URGENT MEDICAL DEVICE CORRECTION

Level 1® H-2 Pressure Chamber Door and Latch Replacement Kits

14 May 2024

Figure 1: Incorrectly installed bag hooks, misoriented 180°

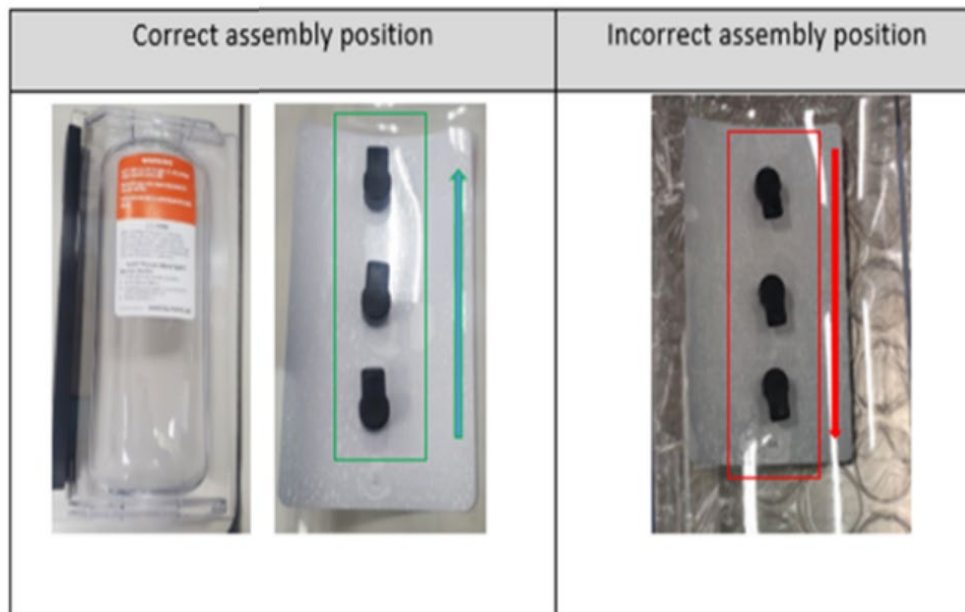
During an internal inspection, it was identified that bag hooks in certain Level 1 H-2 Pressure Chamber Door and Latch Replacement Kits may have been assembled in an incorrect position. Refer to Figure 1 for an image of incorrectly installed bag hooks.

Improperly assembled bag hooks will not allow for proper bag placement within the pressure chamber and may lead to delay of therapy or the inability to complete a full infusion of infusate.

1. Identify all affected Level 1 H2N or 7802722 kits (including those installed into H-2 Pressure Chambers) in your possession:
 - a. Compare the orientation of the bag hooks inside the doors with the correct assembly shown in the above image.

- b. If the bag hooks are assembled correctly, then your product is not affected, and you can continue to use the pressure chamber. Complete the attached Response Form confirming that you have no affected product.

- c. If the bag hooks are assembled incorrectly, then your product is affected, and it will need to be removed from service and replaced. **Do not attempt to use or repair the affected product.** Complete the attached Response Form identifying the number of affected products in your possession.
